To: Plan Holders for Improvements to the  
Washington County Airport  
Mineral Point, Missouri  
MoDOT Project No. 24-060A-1 & 24-060A-2

Transmitted herewith is **Addendum No. 1** to the Issued for Bid Contract Documents, Specifications and Plans dated May 28, 2024, for Improvements to the Washington County Airport.

**ADDENDUM NO. 1  
TO  
CONTRACT DOCUMENTS, SPECIFICATIONS AND PLANS  
FOR IMPROVEMENTS TO THE  
WASHINGTON COUNTY AIRPORT  
MINERAL POINT, MISSOURI  
MODOT PROJECT NO. 24-060A-1 & 24-060A-2**

DEMOLITION PLAN  
STA. 4+50 TO 8+50  
RUNWAY 2/20

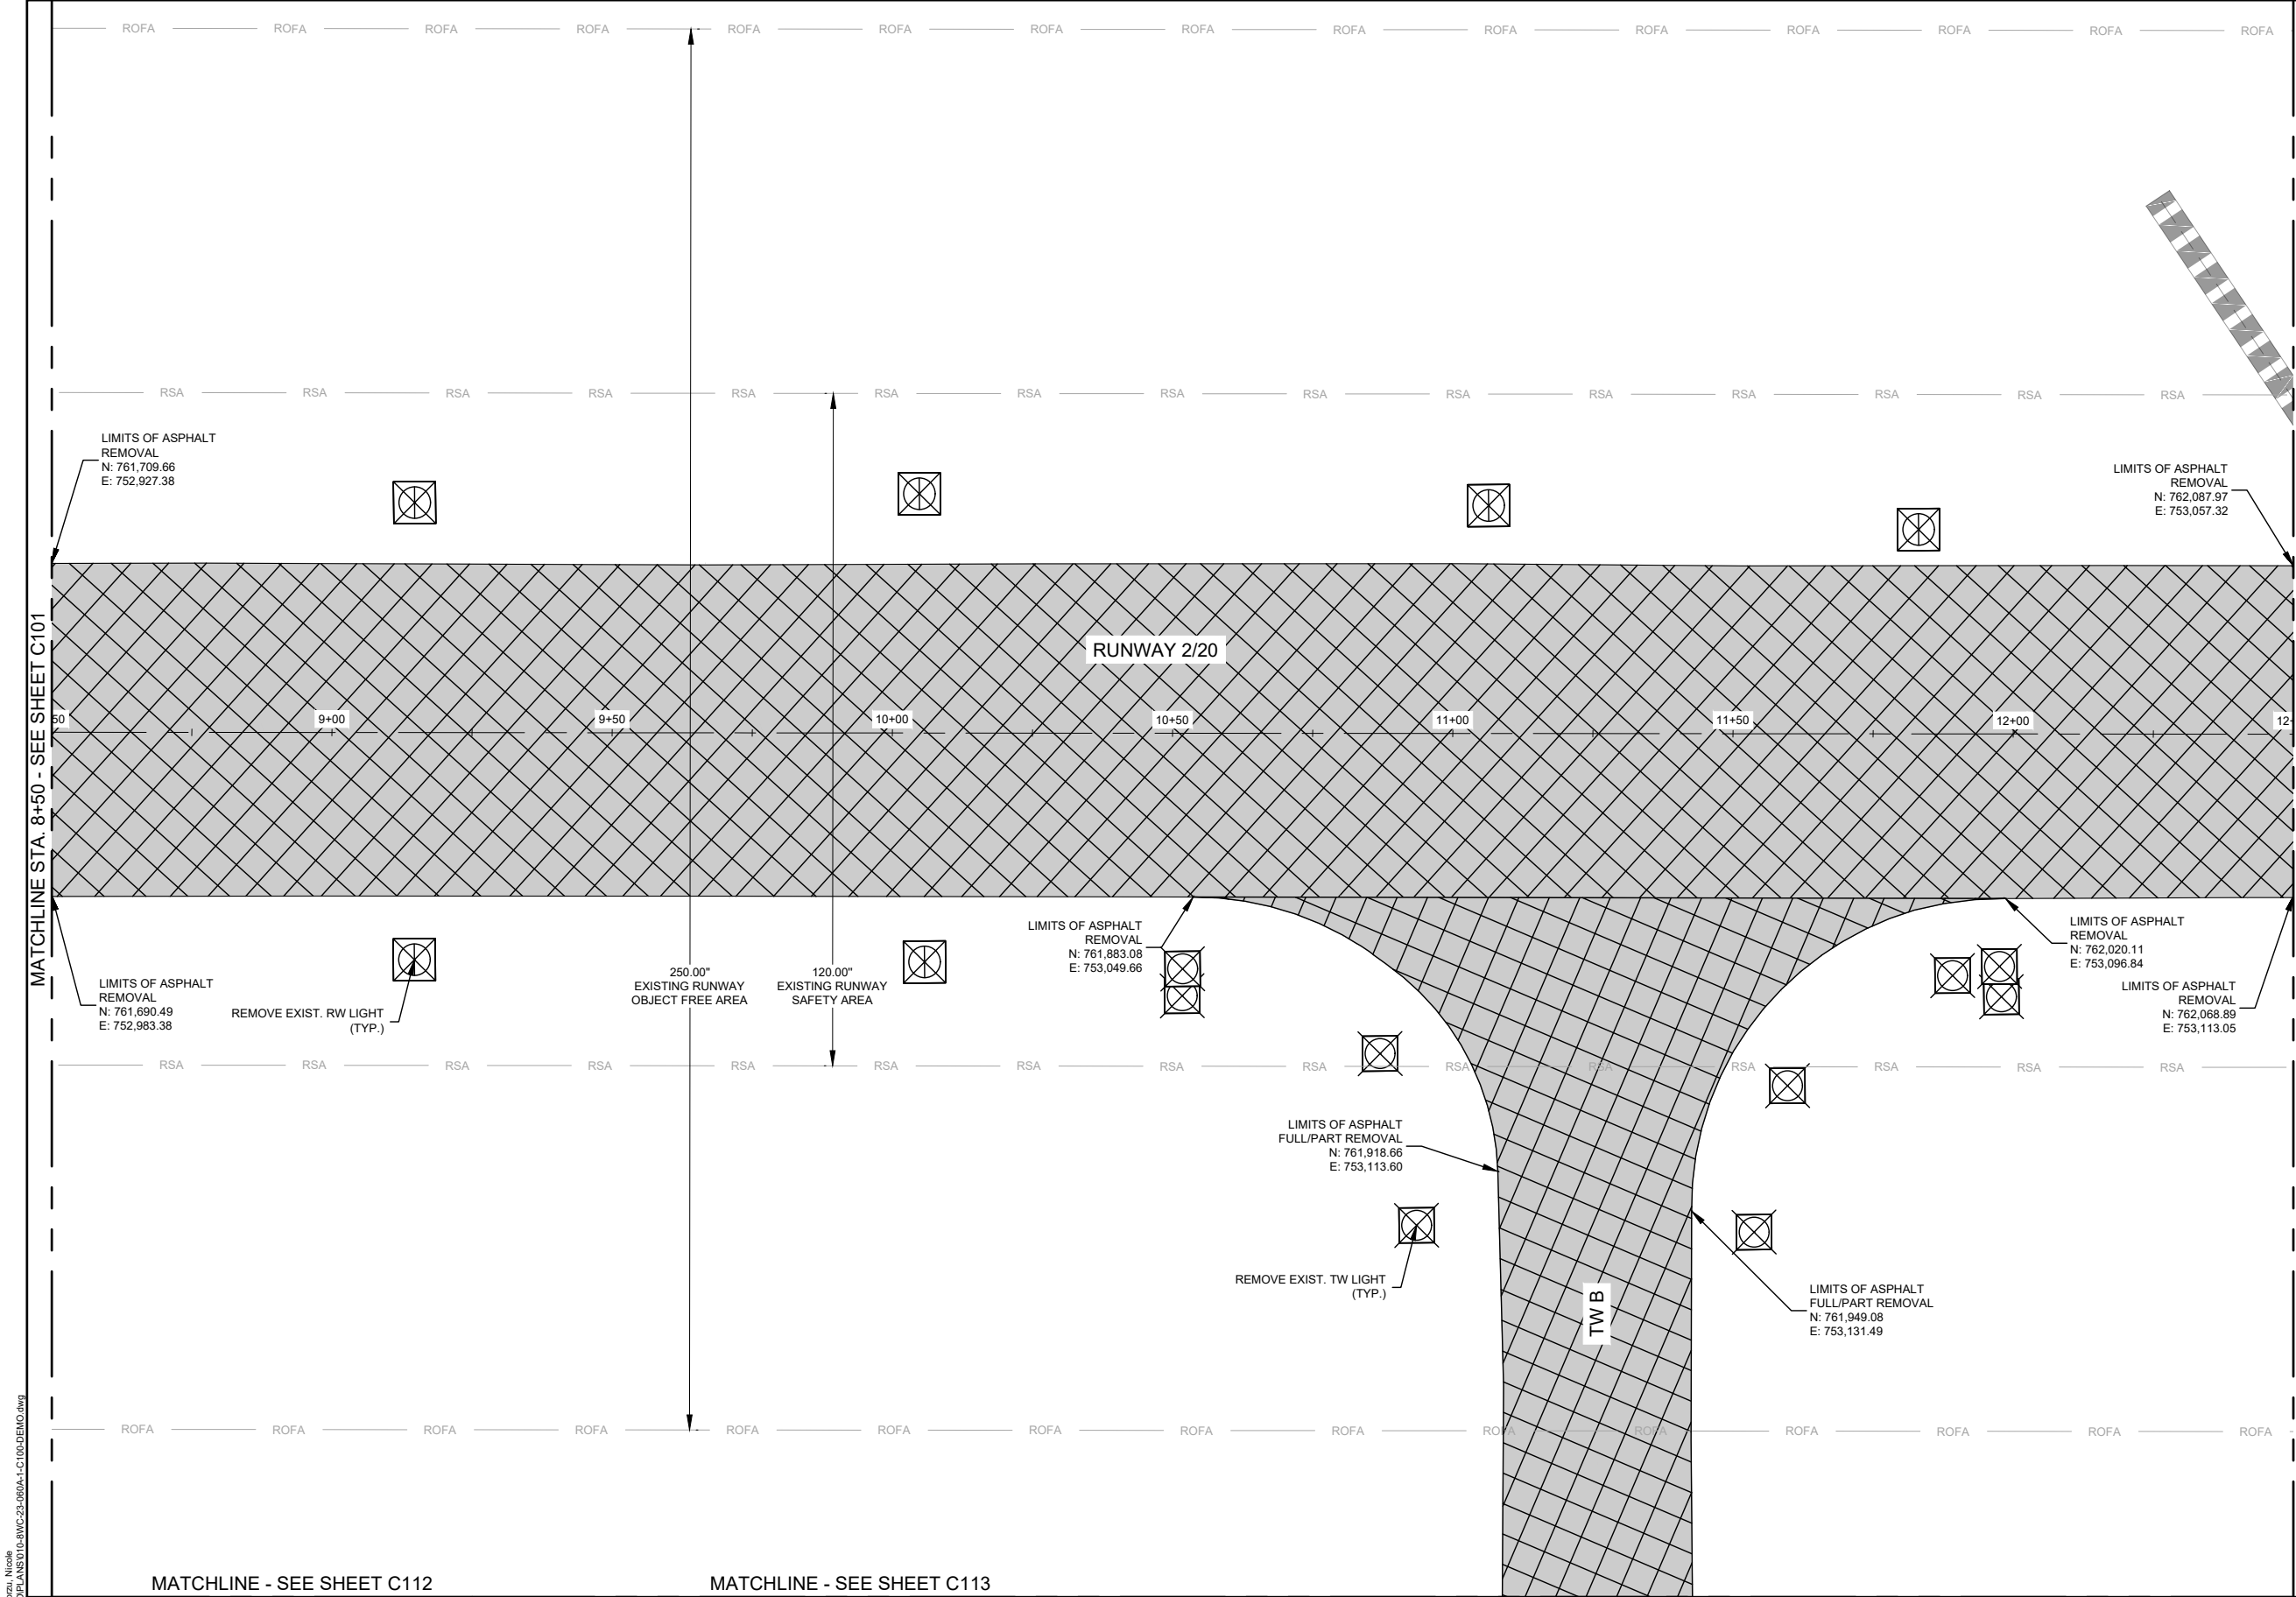
**Justification:** Updated the legend to include a 1.5" Nominal Depth for "Partial Depth Asphalt Removal" and remove the approximate depth from "Clearing and Grubbing".

DEMOLITION PLAN STA. 8+50 TO 12+50 RUNWAY 2/20		SHEET NAME C102
MoDOT PROJ. NO. 24-060A-1 & 24-060A-2	WOOLPERT PROJ. NO. 1015274	
		SHEET NO. 27 of 145

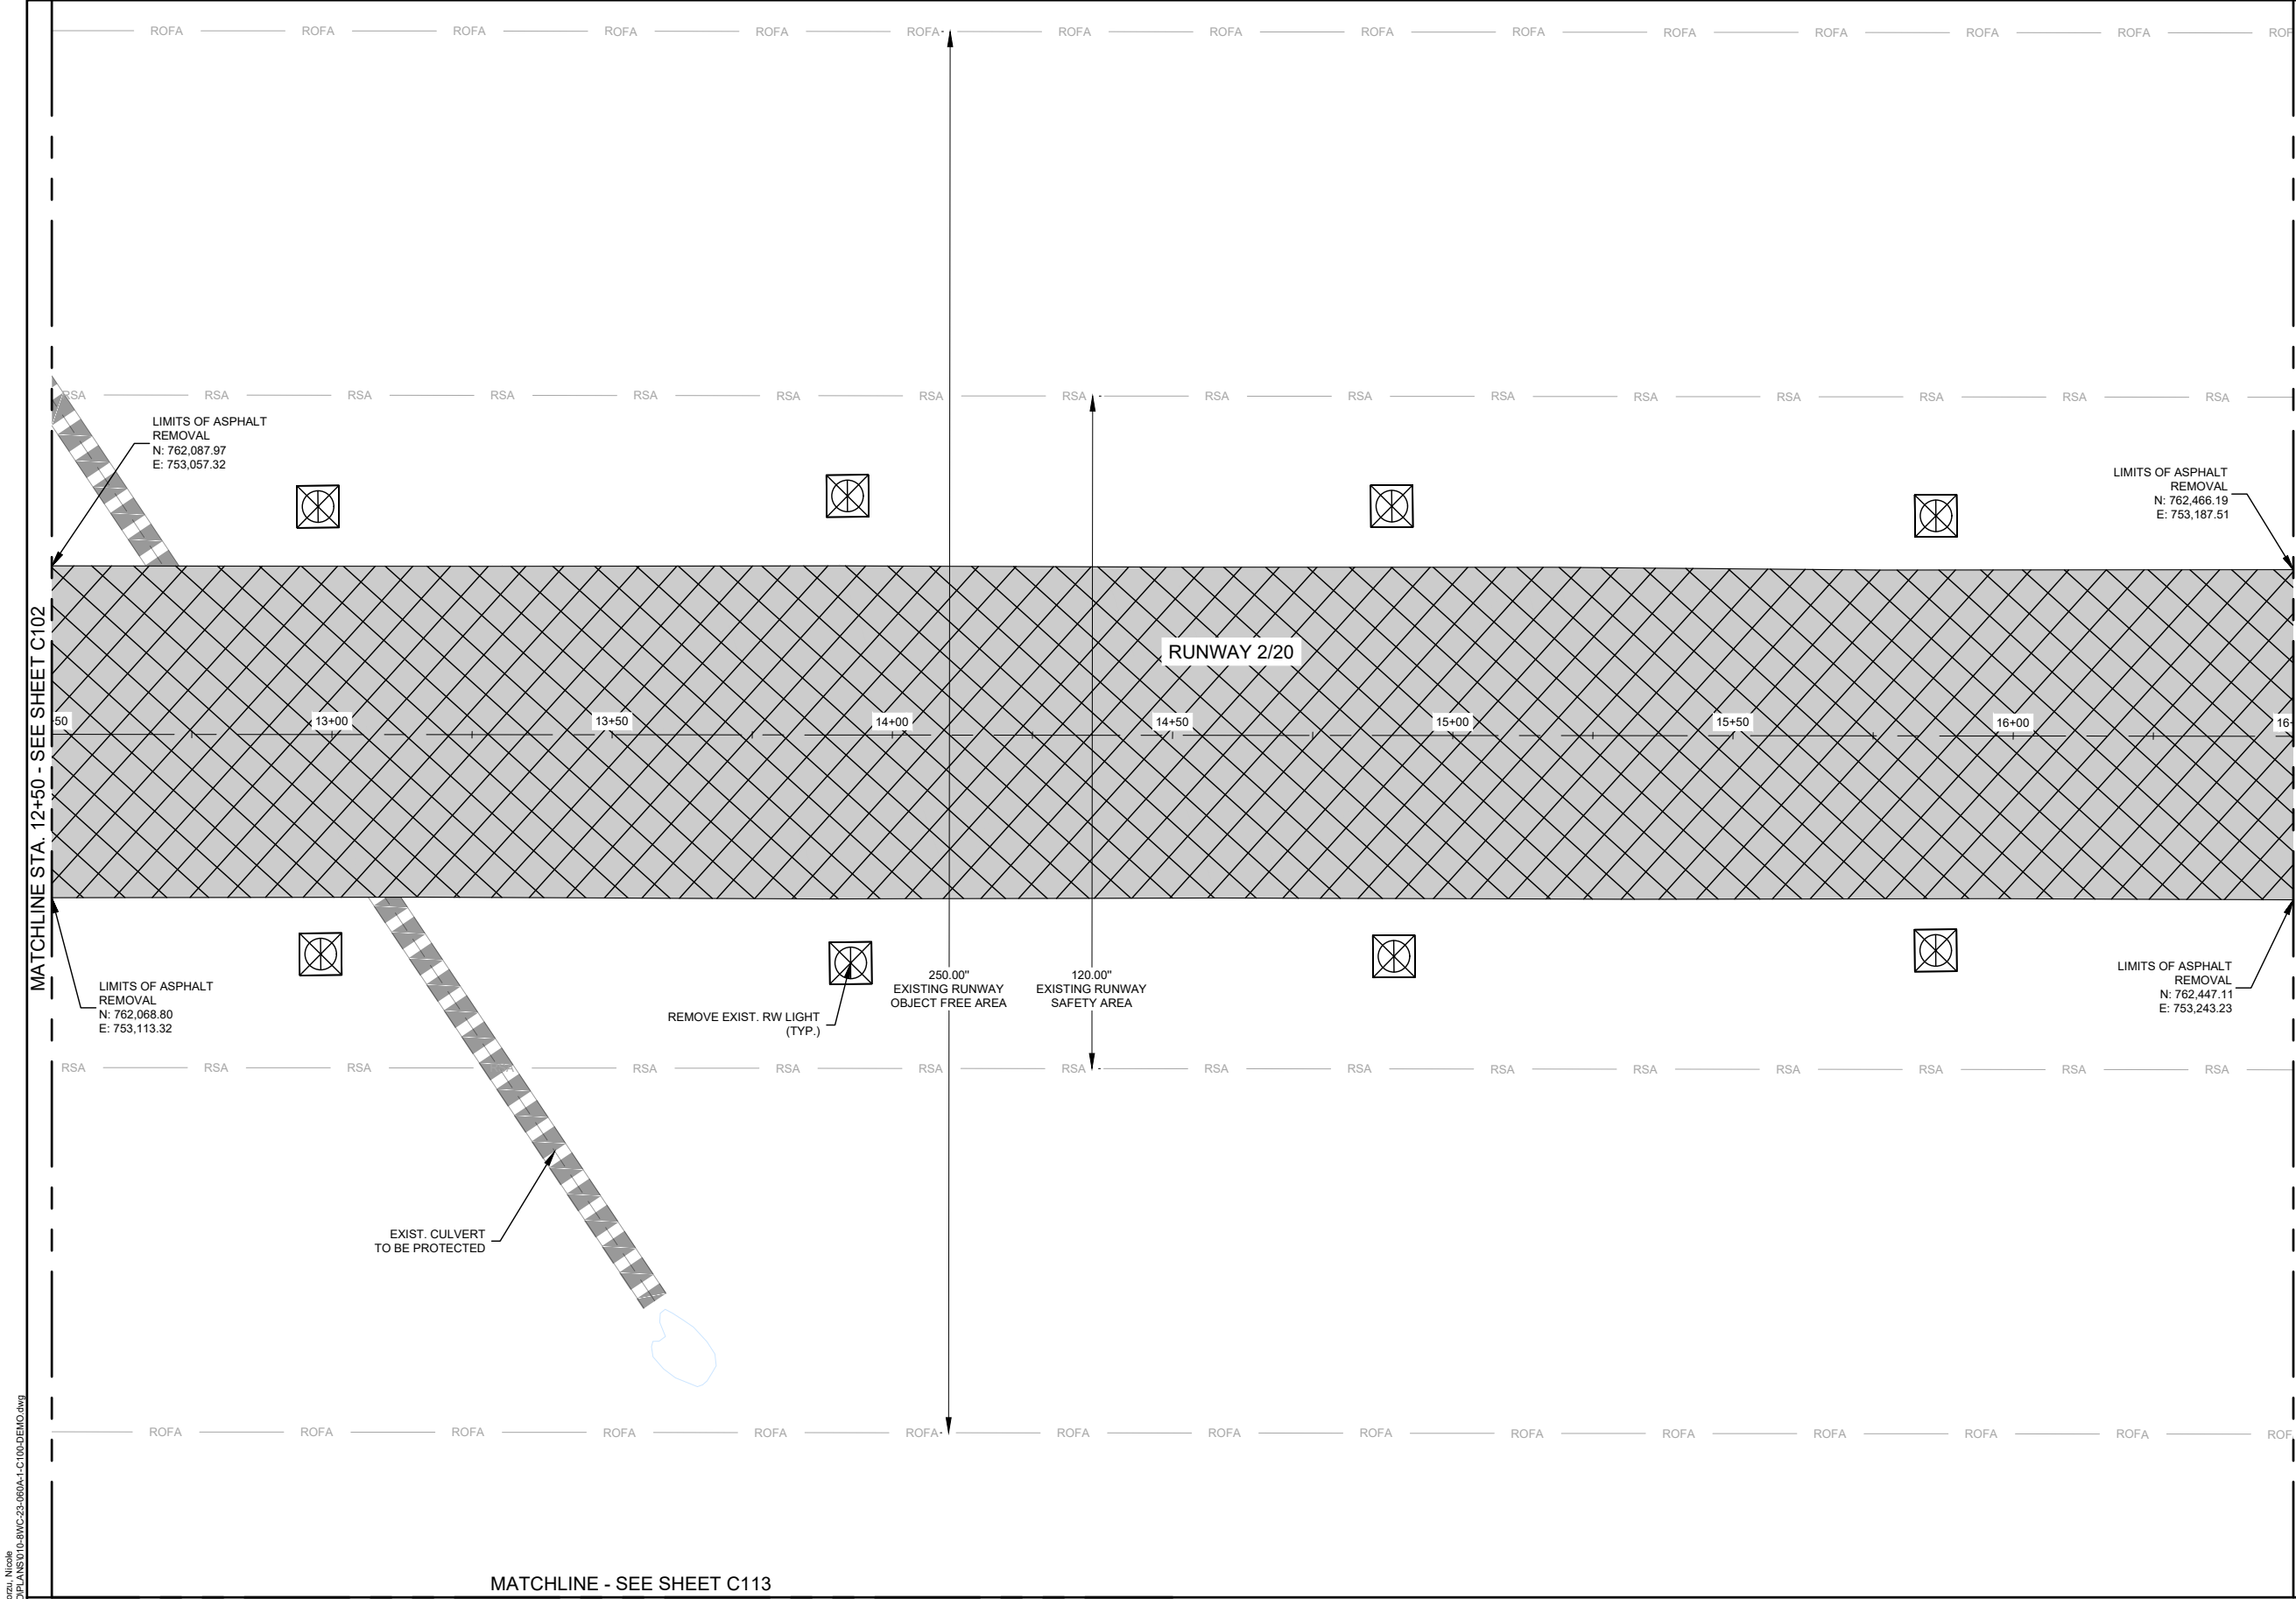
**Justification:** Updated the legend to include a 1.5" Nominal Depth for "Partial Depth Asphalt Removal" and remove the approximate depth from "Clearing and Grubbing".

DEMOLITION PLAN  
STA. 16+50 TO 20+50  
RUNWAY 2/20

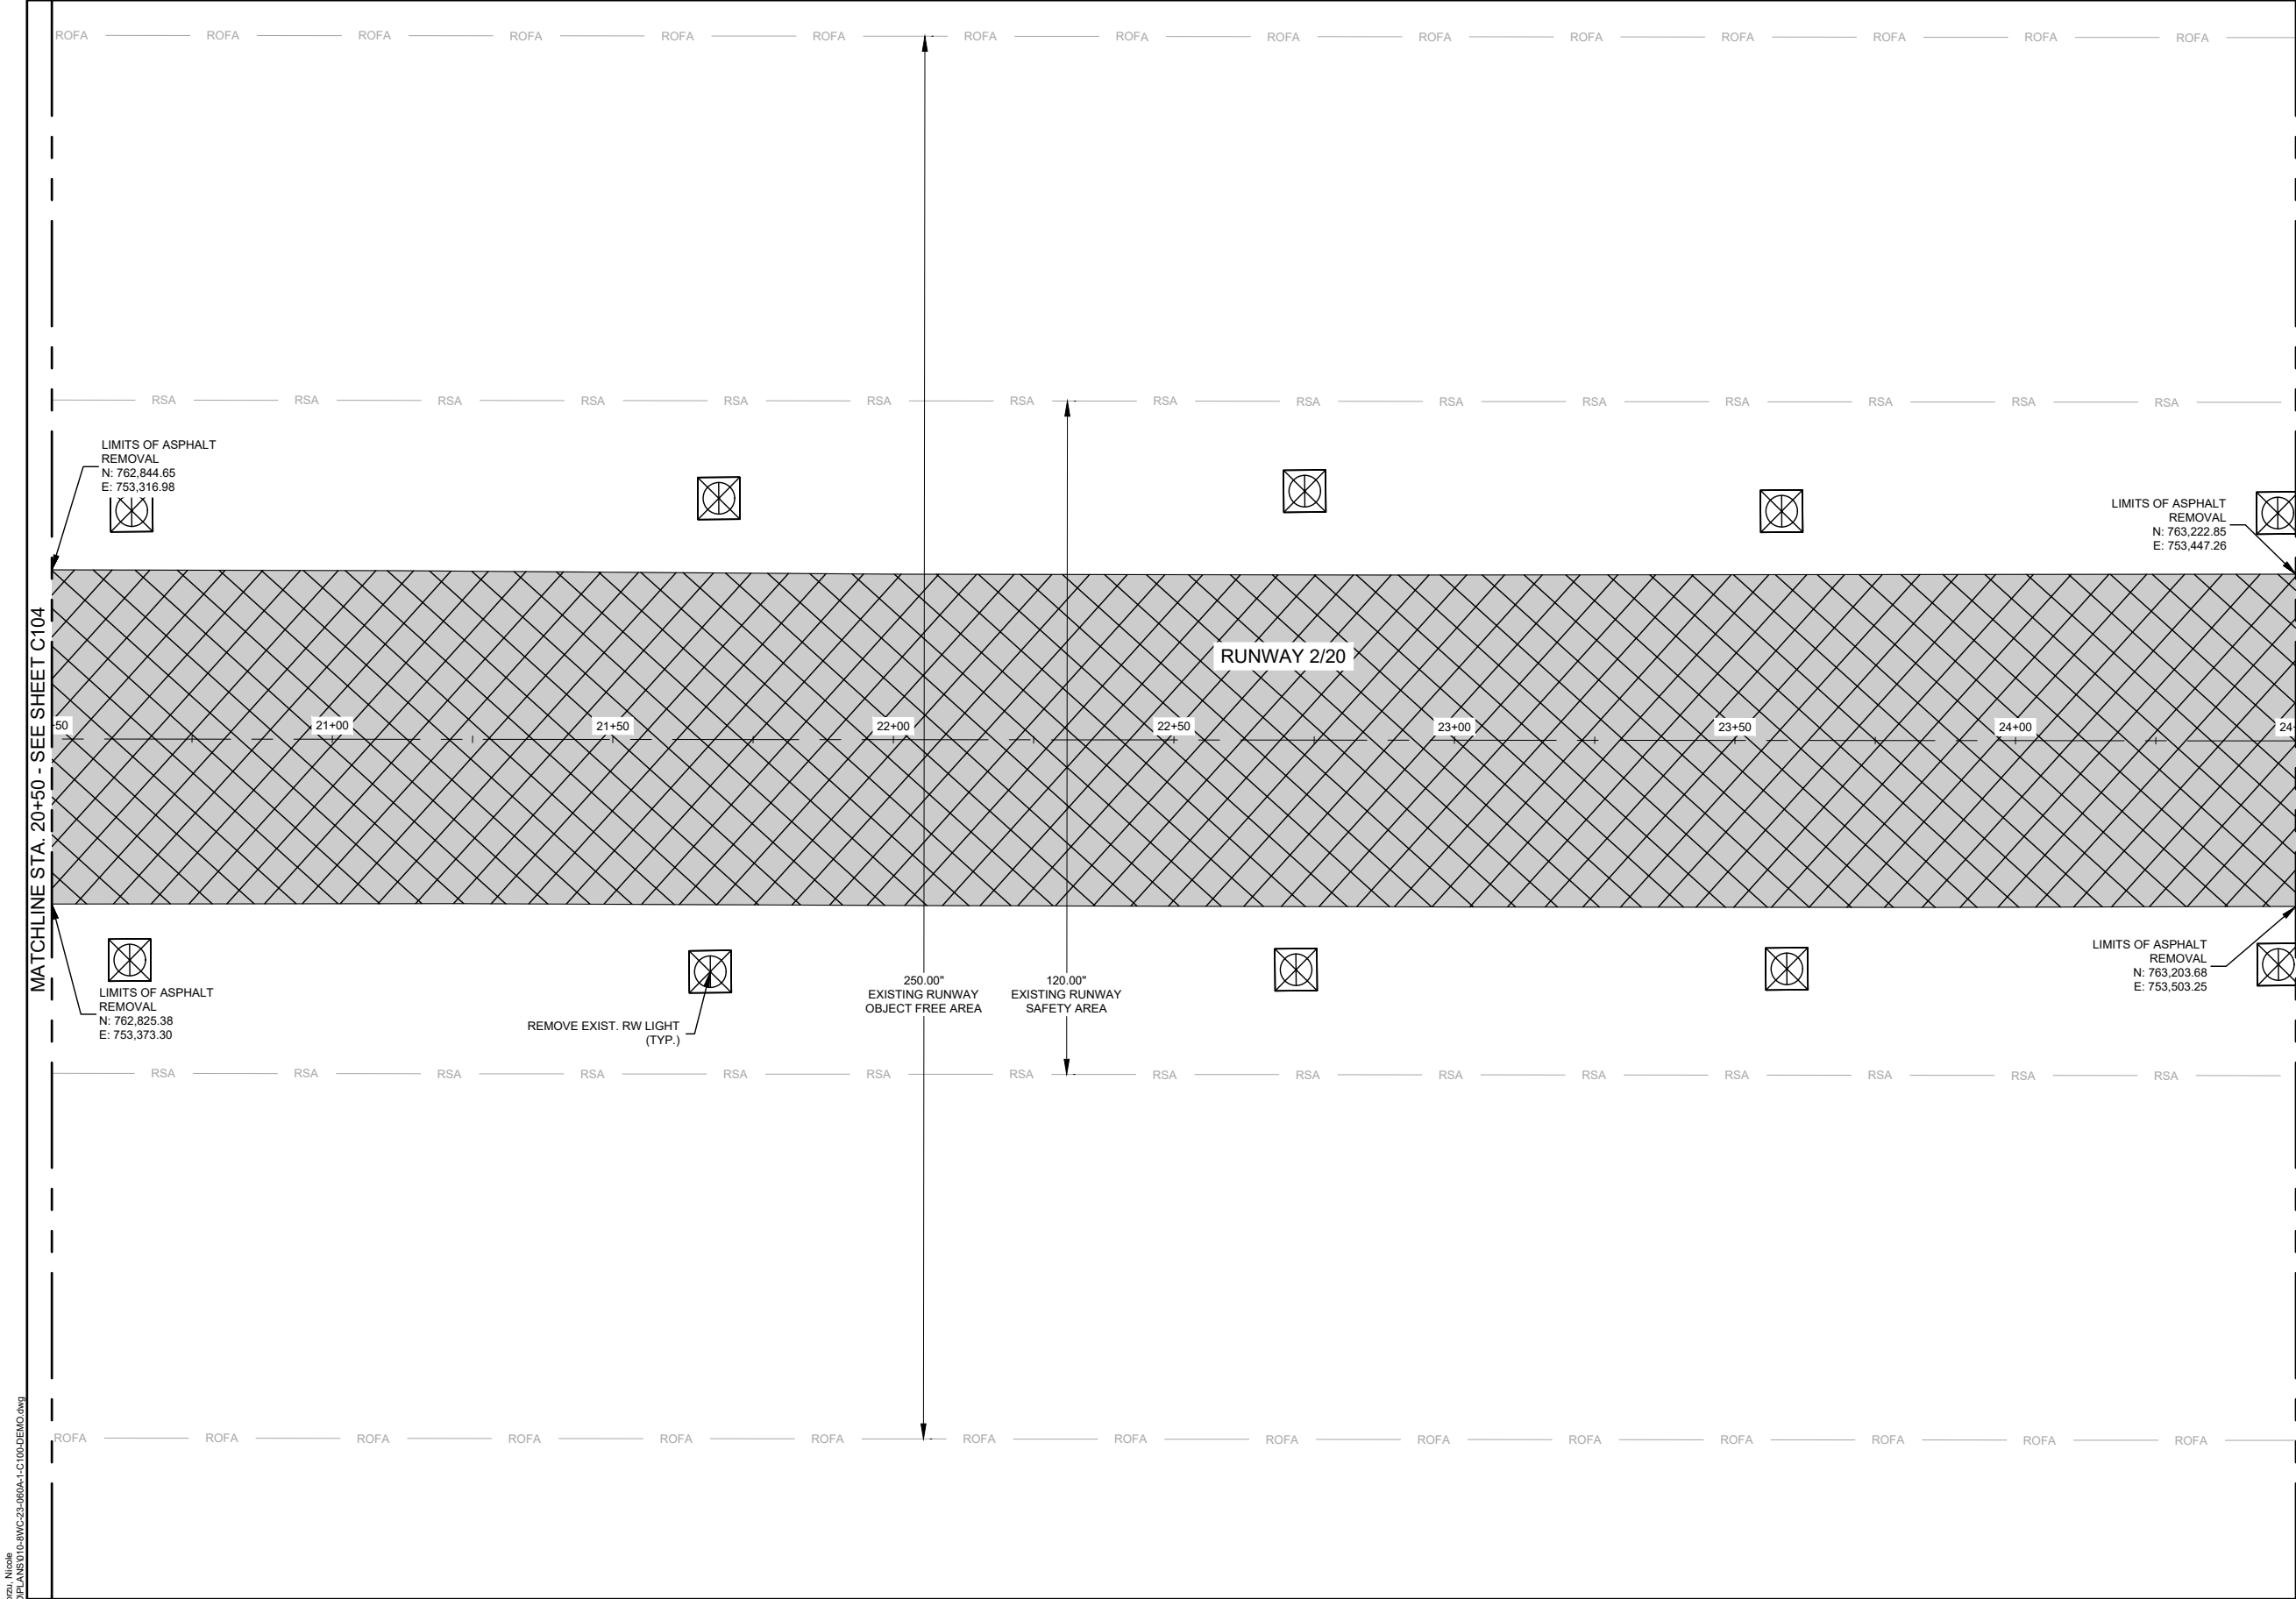
**Justification:** Updated the legend to include a 1.5" Nominal Depth for "Partial Depth Asphalt Removal" and remove the approximate depth from "Clearing and Grubbing".
